**City of Portland, Maine - Building or Use Permit Application**

**BUILDING PERMIT REPORT**

DATE: 24 August 2001 ADDRESS: 39 Alderbrook Road CBL: 085-M-013  
 REASON FOR PERMIT: To Construct a single family dwelling  
 BUILDING OWNER: Carolyn S. Gill  
 PERMIT APPLICANT: \_\_\_\_\_ /CONTRACTOR SAO  
 USE GROUP: R-3 CONSTRUCTION TYPE: 5B CONSTRUCTION COST: \$160,000 PERMIT FEES: \$984.00

**CITY OF PORTLAND, ME  
BOCA 1999 Plan Review Record  
One and Two Family Dwelling**

RIGHT ELEVATION

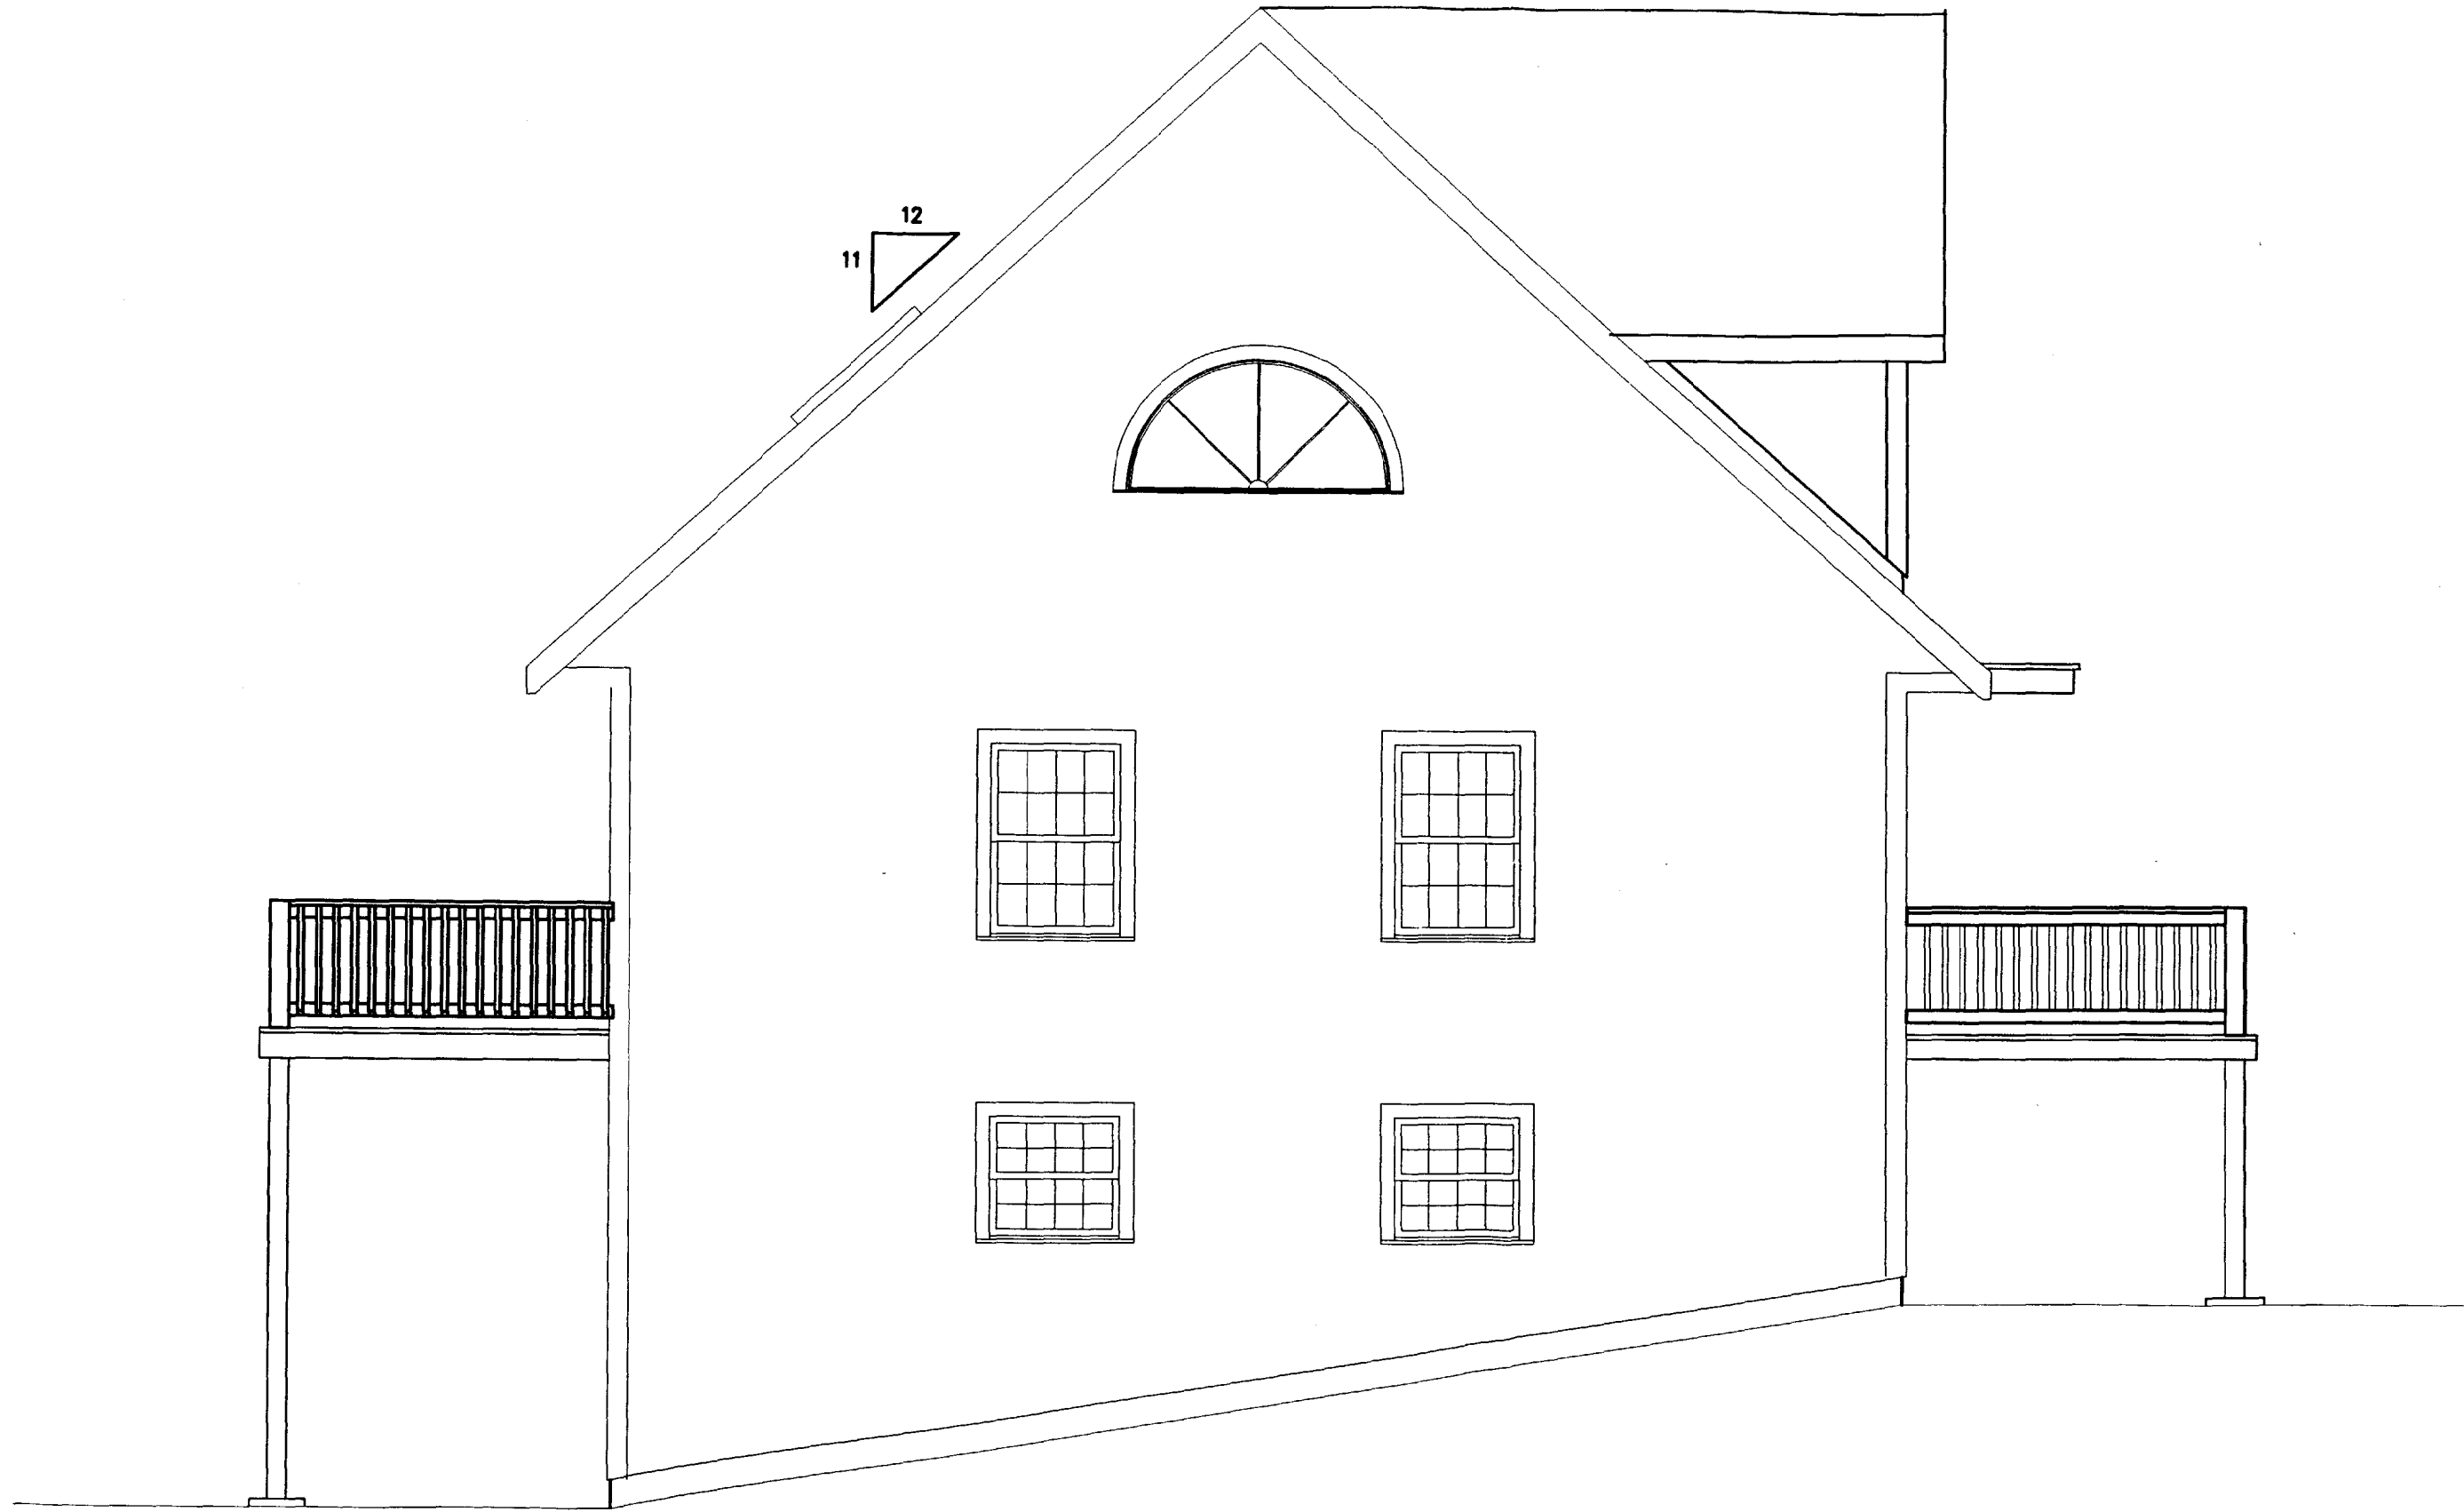
8/21 Revised  
larger Plans  
DC
